S E R V I C E N O T E

J2302B Internet Advisor

Possible fire hazard

Note Drawing shown with the rear panel removed.

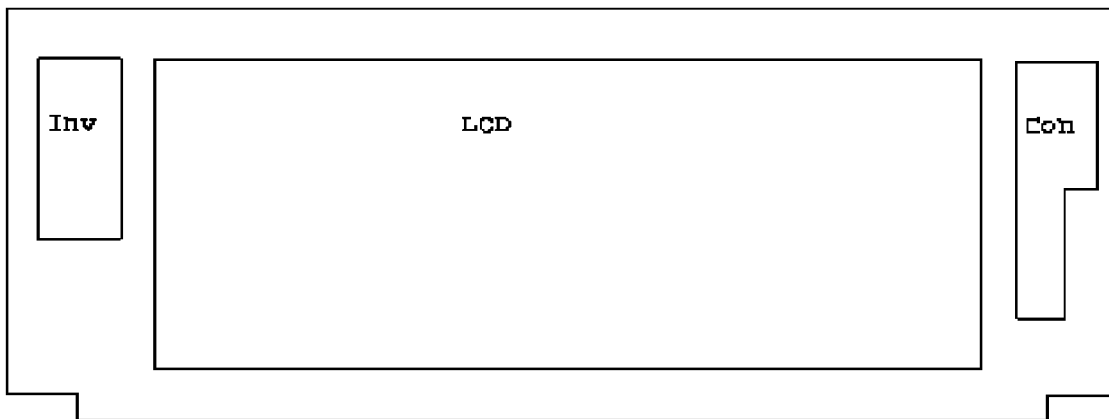
The 0950-2937 Display Board Inverter Assembly installed into the J2302B display does not meet Agilent's Fire Retardant standards and should be replaced. Inverter boards 0950-2937 marked with LOT 56 on the transformer in instruments with the serial number listed should have this modification to prevent instrument damage.

1. Remove the back panel from the display by removing 6 painted screws.
2. Locate 0950-2937 (note drawing marker “Inv”), remove 2 screws and cables from the board and remove the inverter board from the display assembly.
3. Replace the board with 0950-2937 with different LOT number.
